SUBJECT: UNITS 2/3 OFFSITE DOSE CALCULATION MANUAL Revision 24

Enclosed is Revision 24 to the Units 2/3 Offsite Dose Calculation Manual (ODCM). This revision added the component cooling water, storage tank area, and auxiliary building sumps as liquid release points and updated default flow rates from the common plant vent stack. Additionally, radiation monitor calibration constants were updated to reflect recent surveillances and there was one editorial change for typographical errors. None of the changes result in any modifications to either the plant configuration or operation. As such, there is no impact on the accuracy or reliability of methods for determining effluent dose or setpoint values.

OFFSITE DOSE CALCULATION MANUAL

Revision 24  
08-31-91

FIGURE 4-5: SONGS 2&3 RADIOACTIVE LIQUID WASTE TREATMENT SYSTEMS

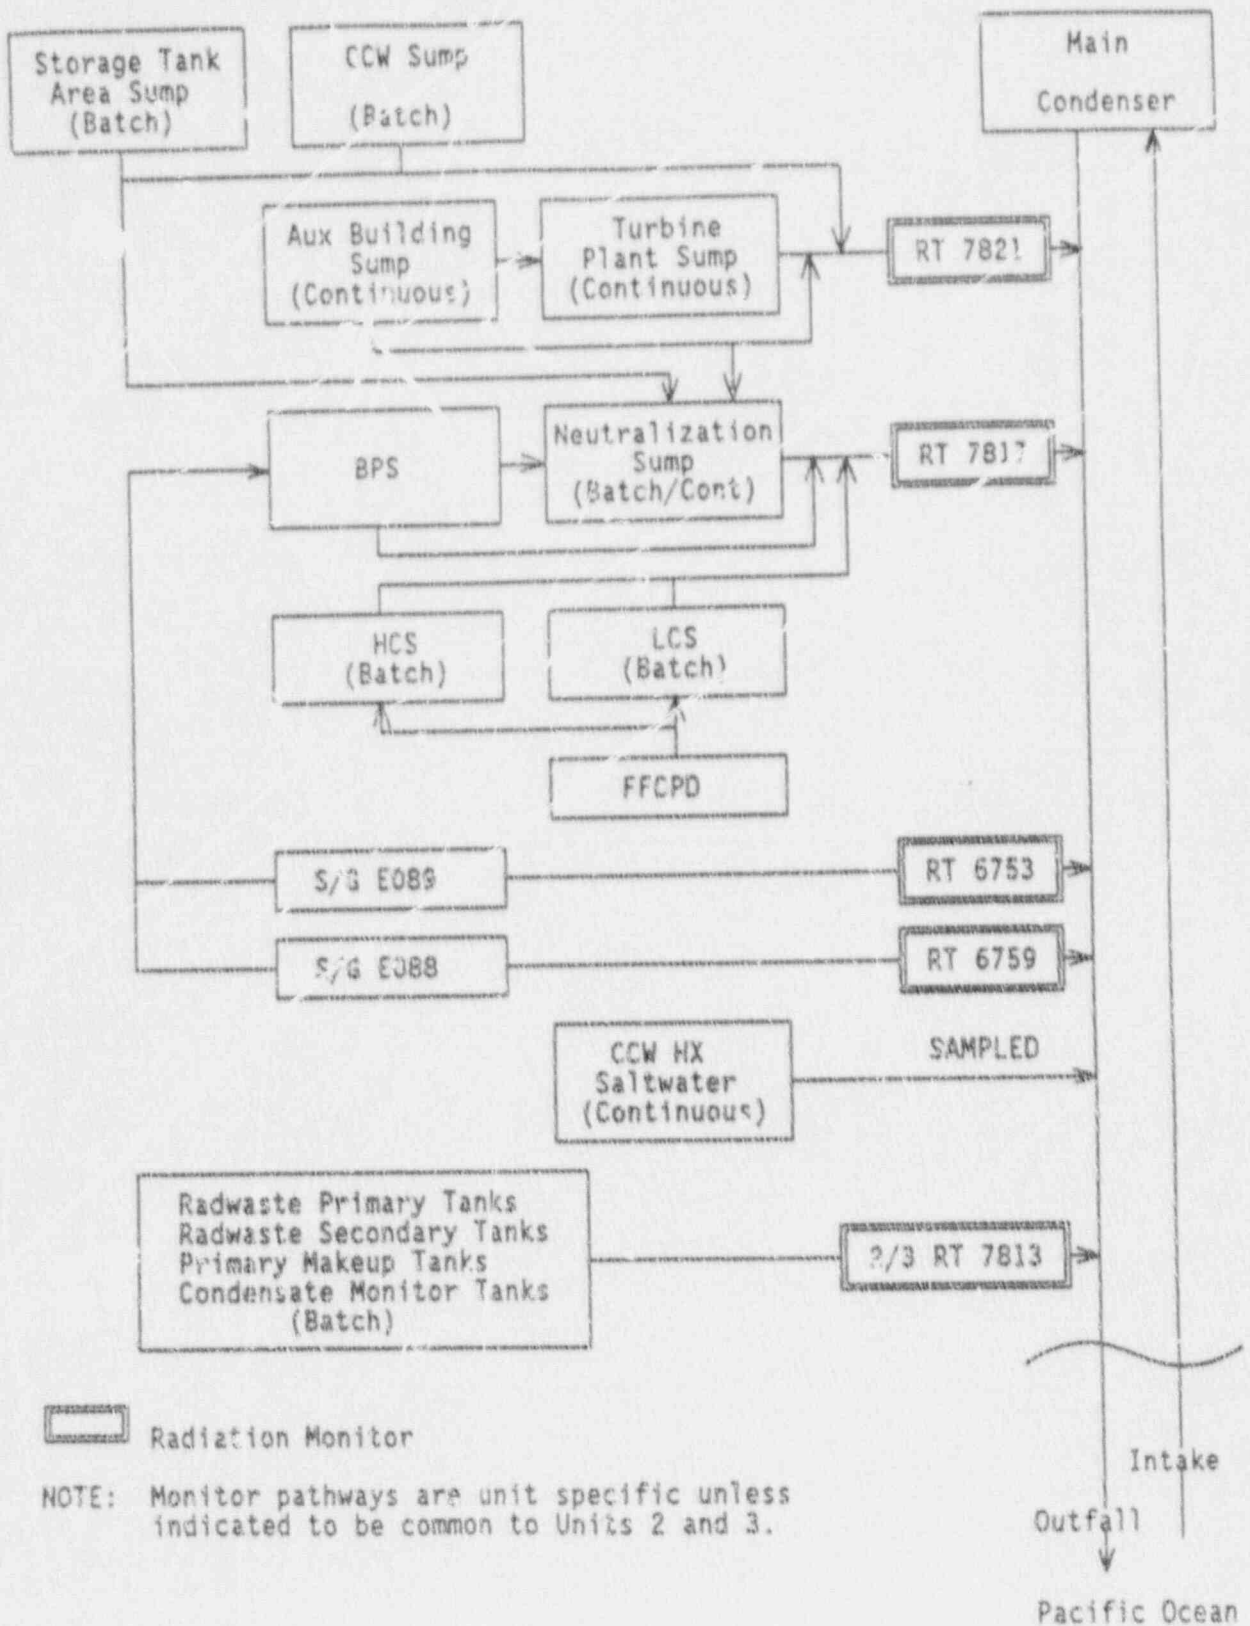
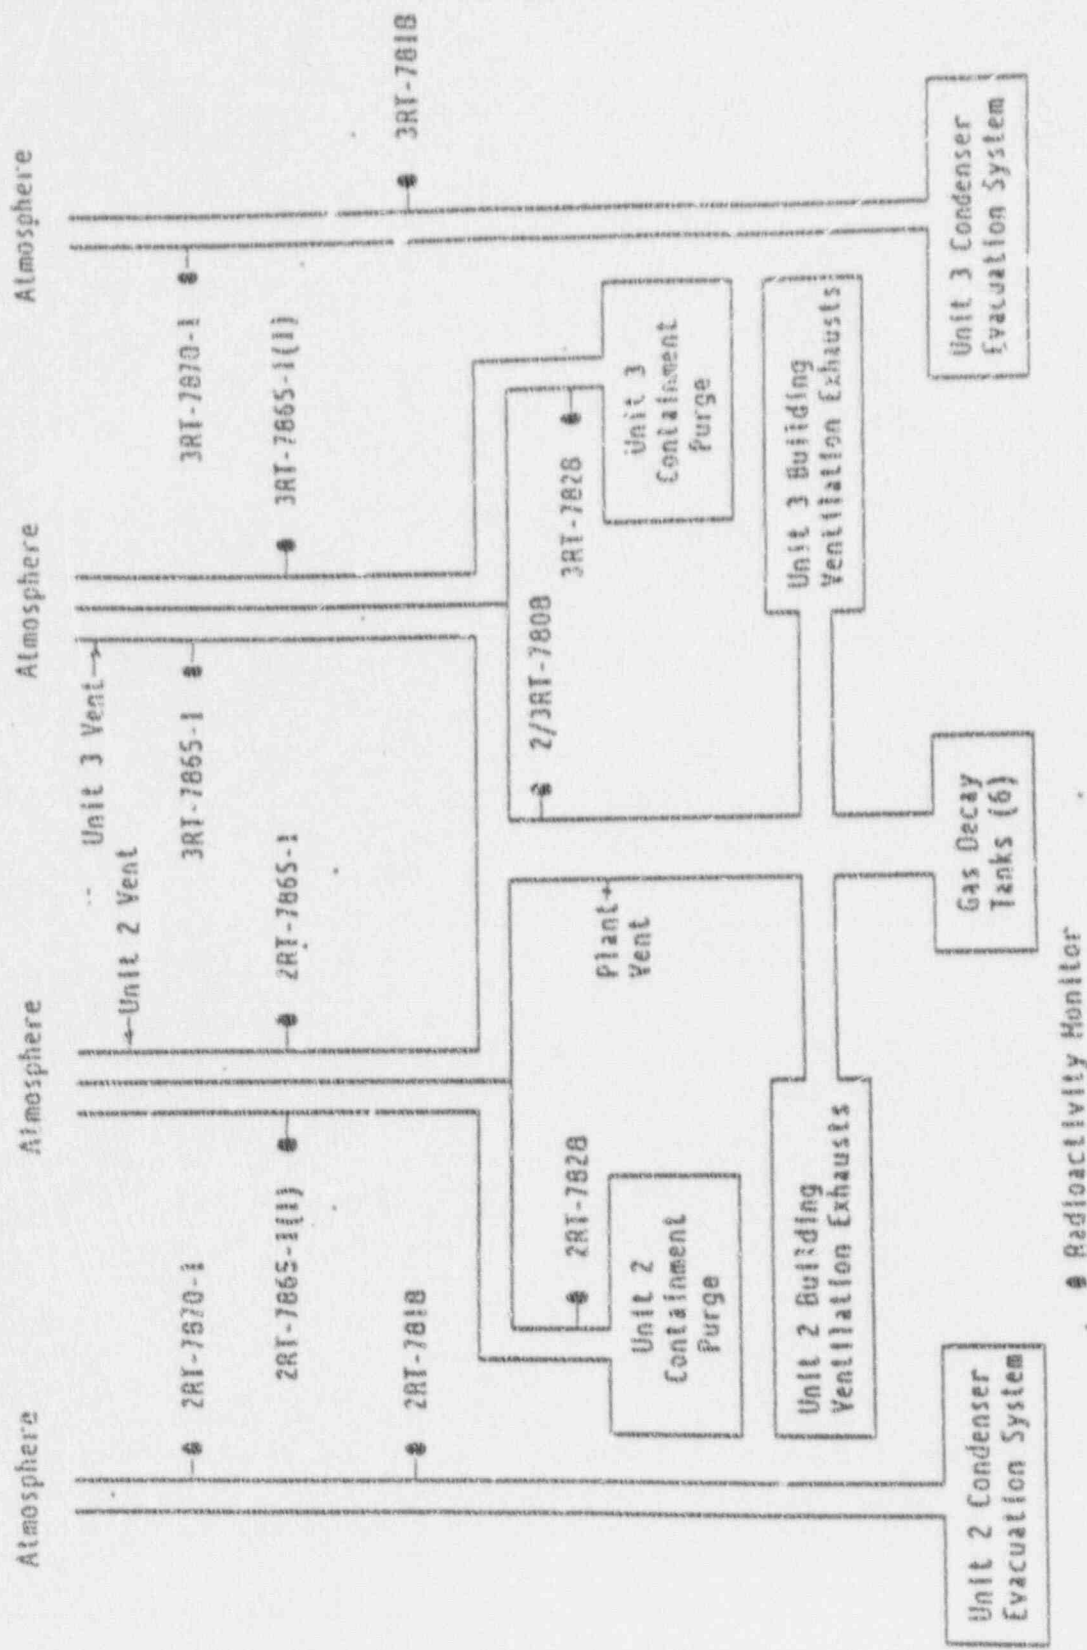
- 4-14 Figure 4-5 updated to reflect additional liquid release points.
